Overheating Risk Assessment

Land North of Arundel Road, Fontwell

For Harlequin Developments

Appendix D – Overheating markups

Drawing Title
Floor Plans and Elevations - HT01A and HT01B

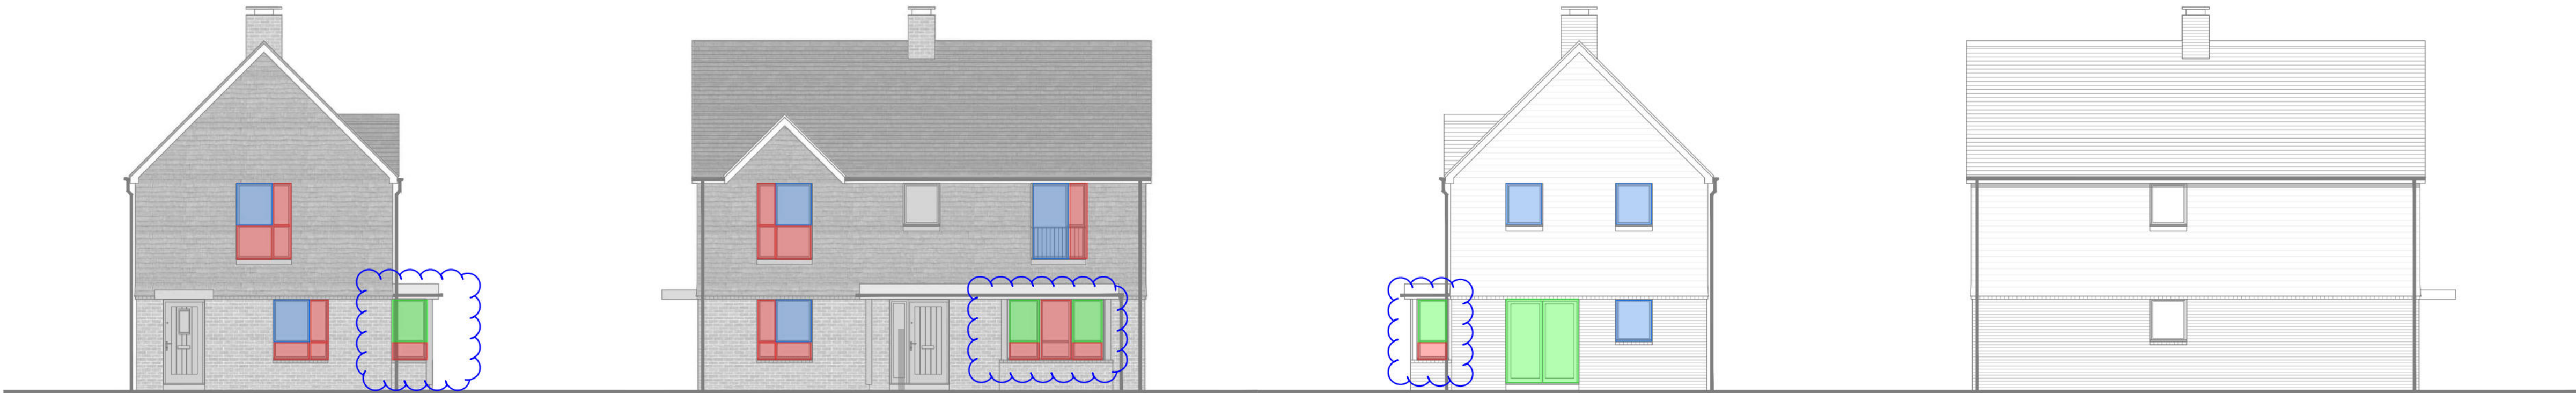
1) Please review transom or bottom of window heights for all window assemblies on upper floors where there is risk of falling. Part O (2021) guidance requires transoms to be at 1.1m above FFL to enable openable windowpanes above the transom to be fully openable. From our review of section drawings, the scheme is compliant but ECE please confirm.

2) All windows to have a g-value of 0.4.

3) For plots where bedrooms do not deviate from ADO noise criteria:

Please ensure all Ground Floor (GF) Kitchen, Living, Dining (KLD) spaces can achieve a small opening (circa 0.1m² unobstructed free area per room) to provide night-time ventilation securely.

5) Current assessment based on ADO (2021) and CIBSE TM59 (2017). Final strategy to be confirmed based on ADO calculations to be carried out at detailed design and construction stages post-planning with the applicable guidance and regulations at the time of detailed design and construction stages.

Drawing Title
Floor Plans and Elevations - HT01A and HT01B Semi

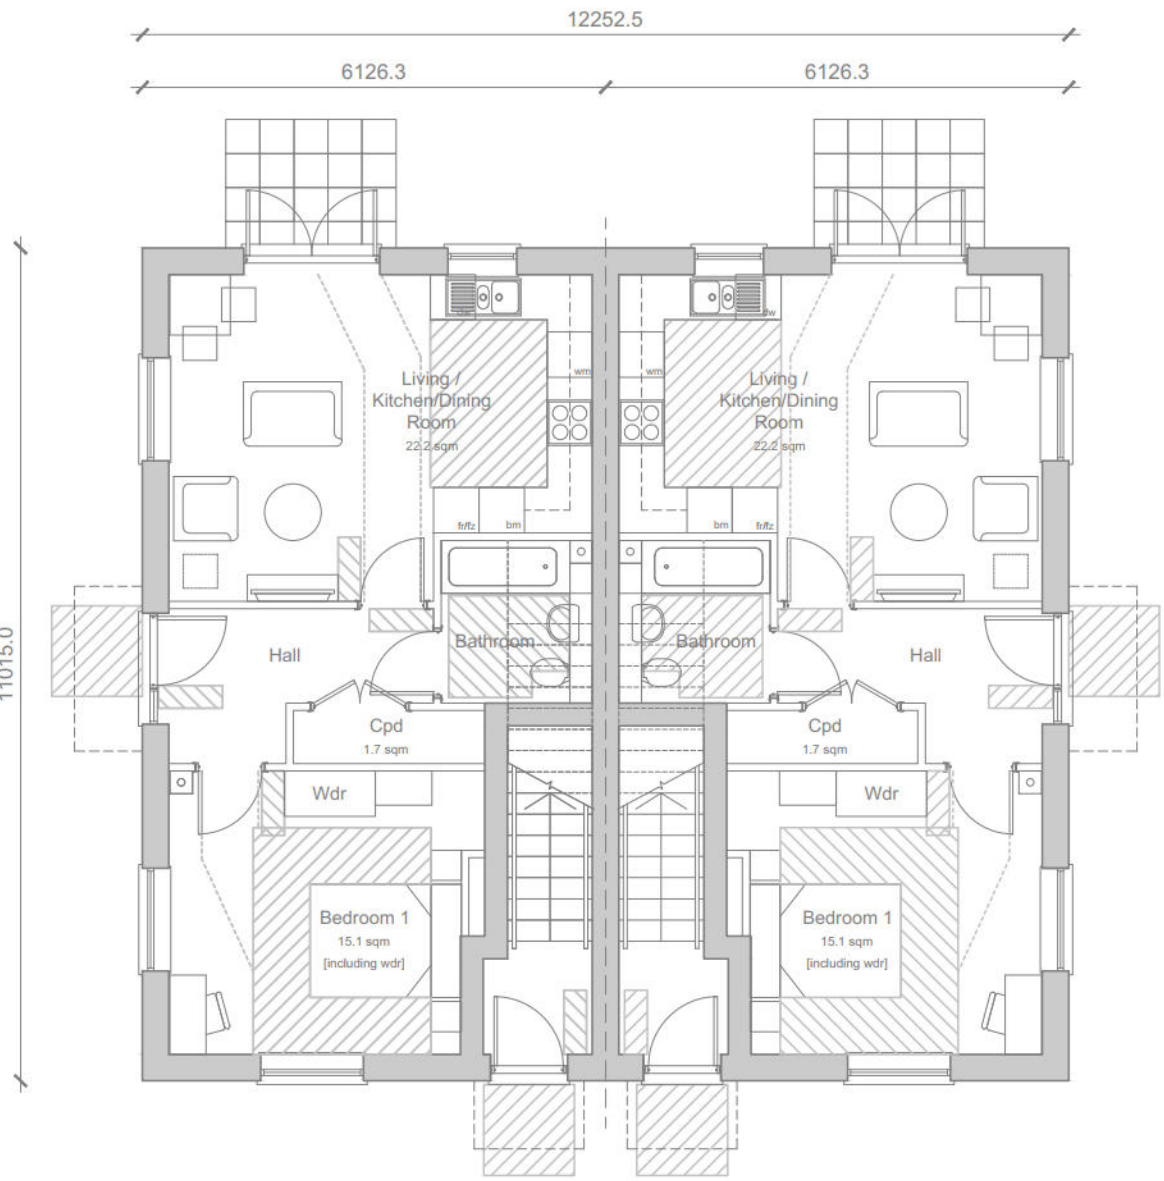
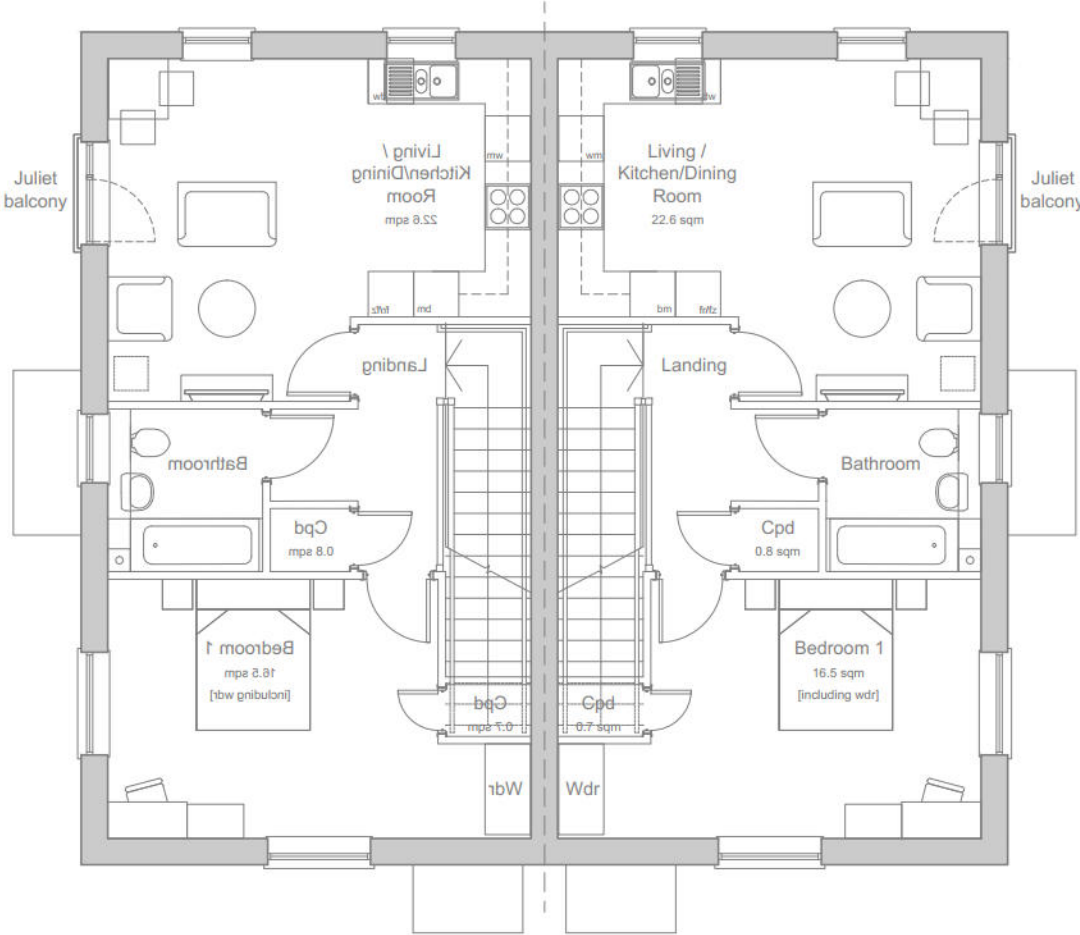
1) Please review transom or bottom of window heights for all window assemblies on upper floors where there is risk of falling. Part O (2021) guidance requires transoms to be at 1.1m above FFL to enable openable windowpanes above the transom to be fully openable. From our review of section drawings, the scheme is compliant but ECE please confirm.

2) All windows to have a g-value of 0.4.

3) For plots where bedrooms do not deviate from ADO noise criteria:

Please ensure all Ground Floor (GF) Kitchen, Living, Dining (KLD) spaces can achieve a small opening (circa 0.1m² unobstructed free area per room) to provide night-time ventilation securely.

5) Current assessment based on ADO (2021) and CIBSE TM59 (2017). Final strategy to be confirmed based on ADO calculations to be carried out at detailed design and construction stages post-planning with the applicable guidance and regulations at the time of detailed design and construction stages.

Drawing Title
Floor Plans and Elevations - HT02A and HT04

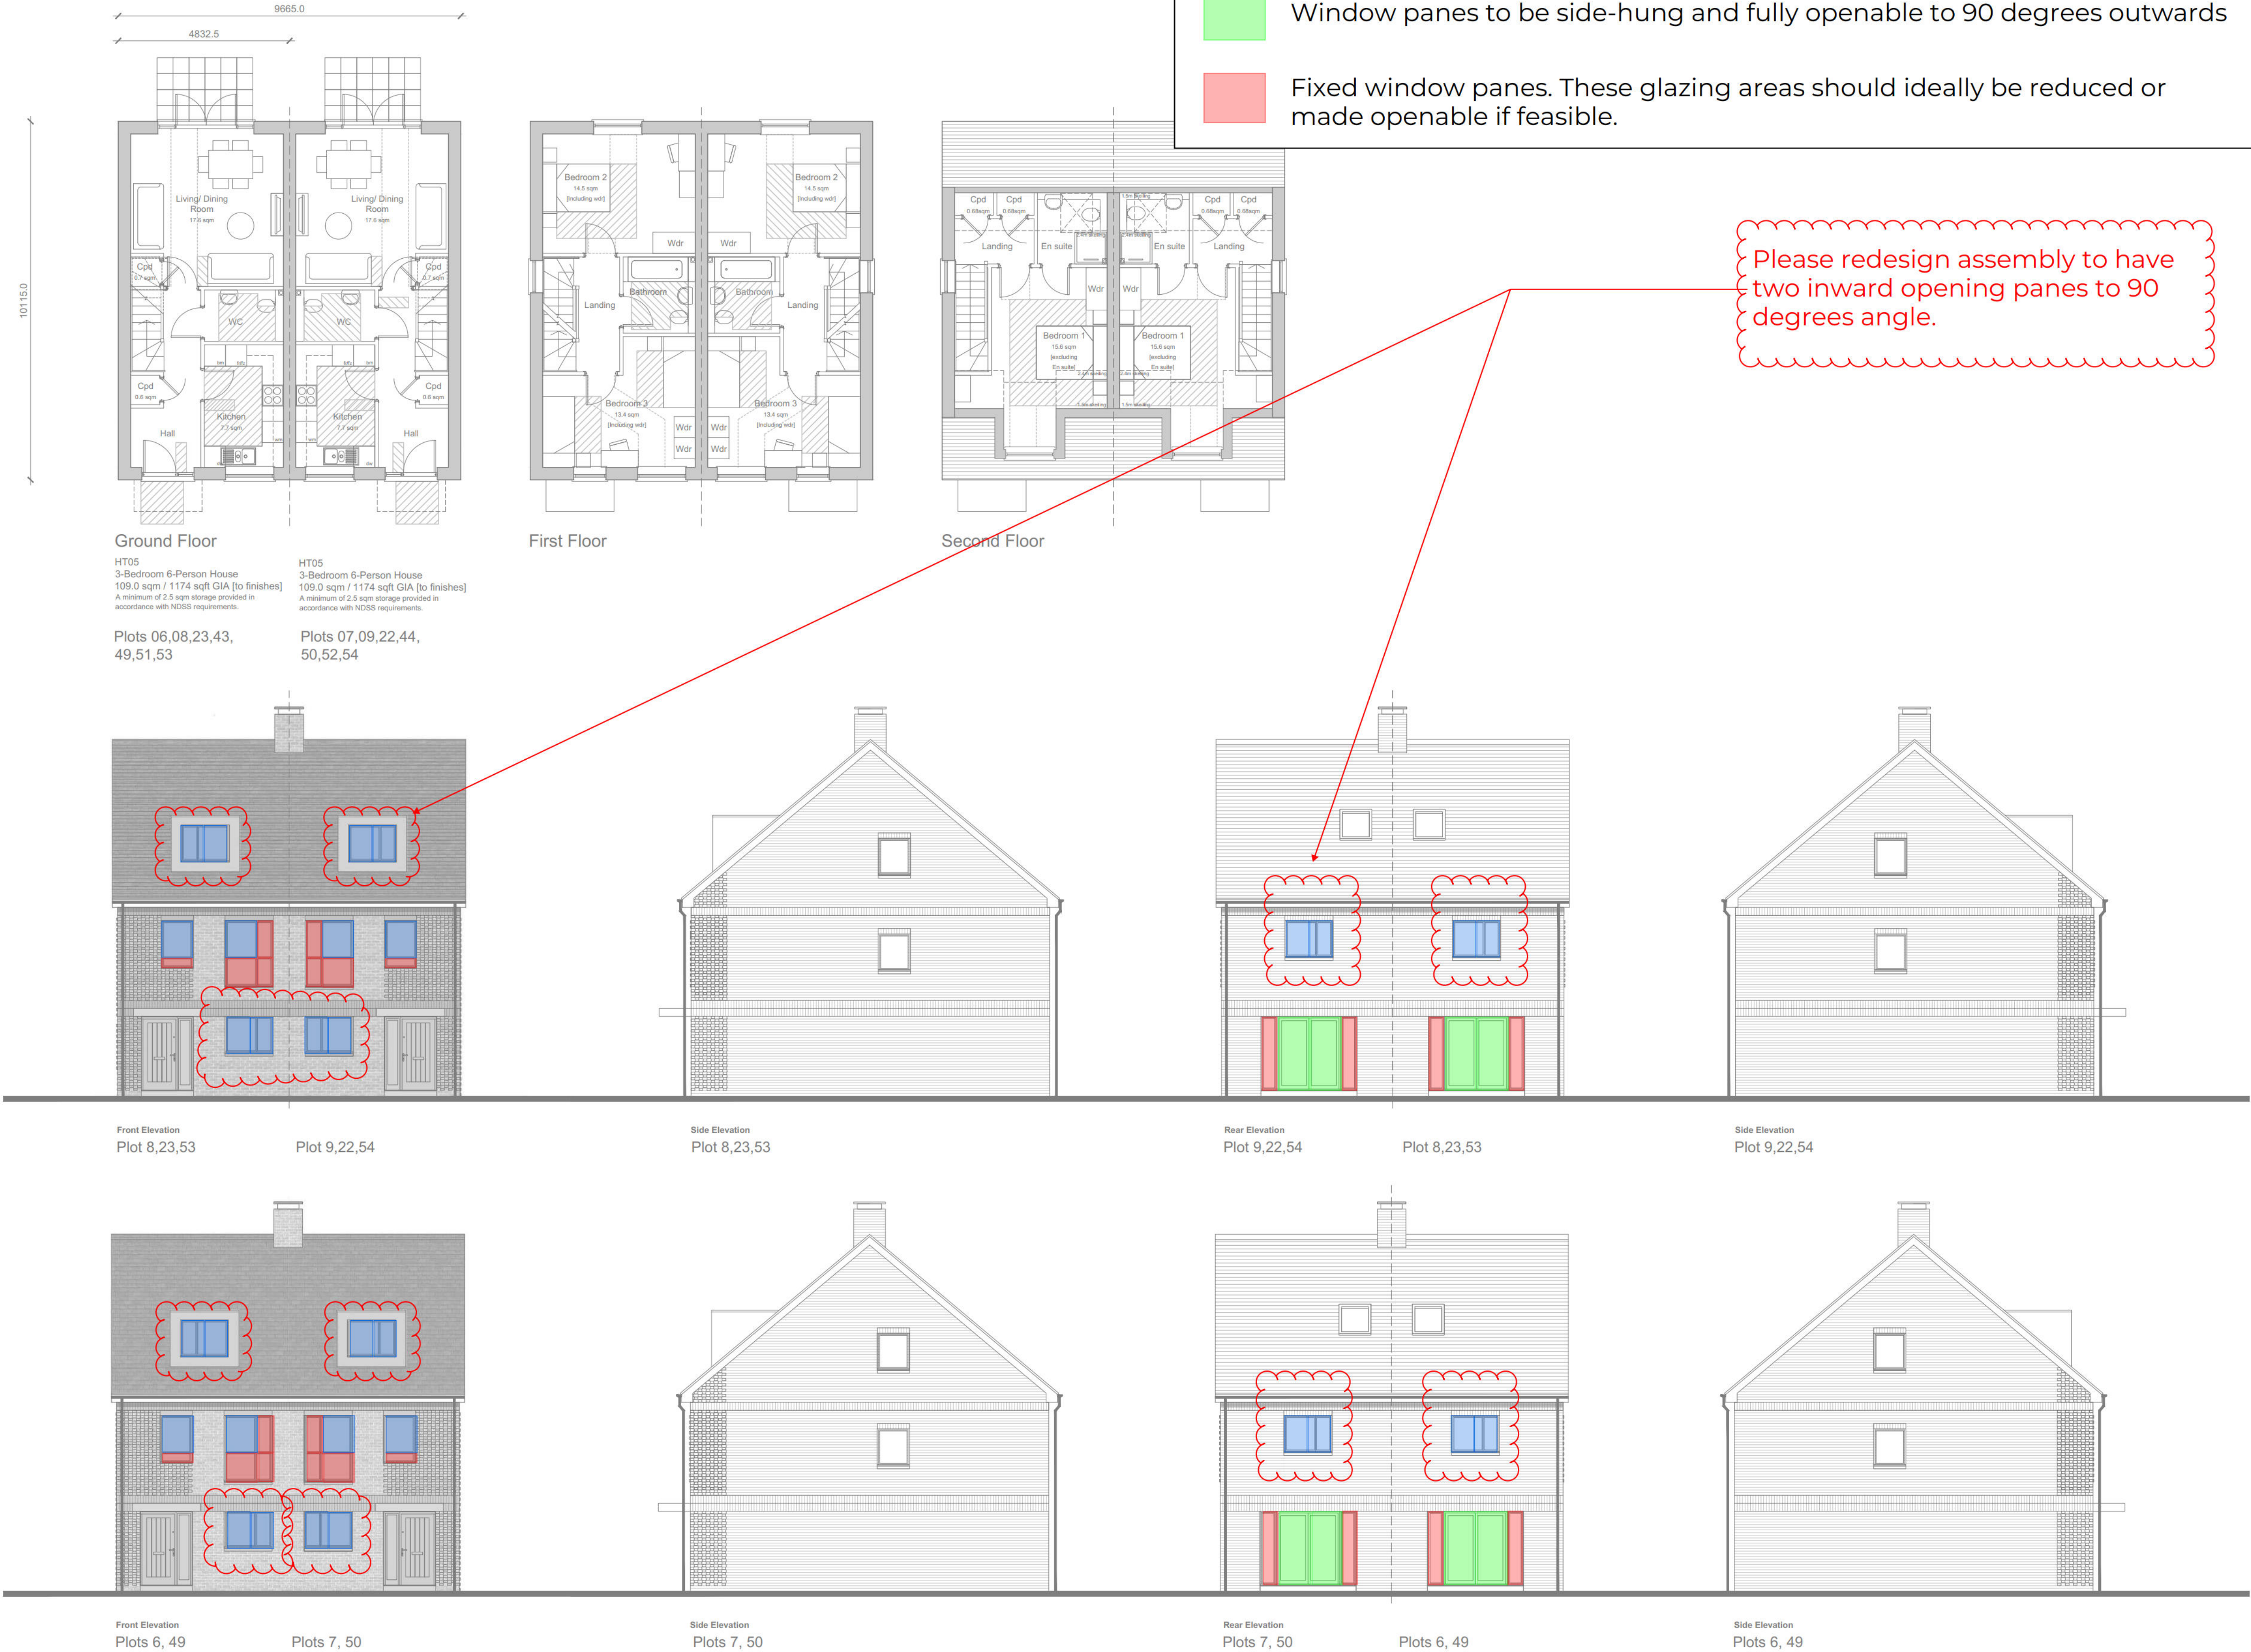
1) Please review transom or bottom of window heights for all window assemblies on upper floors where there is risk of falling. Part O (2021) guidance requires transoms to be at 1.1m above FFL to enable openable windowpanes above the transom to be fully openable. From our review of section drawings, the scheme is compliant but ECE please confirm.

2) All windows to have a g-value of 0.4.

3) For plots where bedrooms do not deviate from ADO noise criteria:

Please ensure all Ground Floor (GF) Kitchen, Living, Dining (KLD) spaces can achieve a small opening (circa 0.1m² unobstructed free area per room) to provide night-time ventilation securely.

5) Current assessment based on ADO (2021) and CIBSE TM59 (2017). Final strategy to be confirmed based on ADO calculations to be carried out at detailed design and construction stages post-planning with the applicable guidance and regulations at the time of detailed design and construction stages.
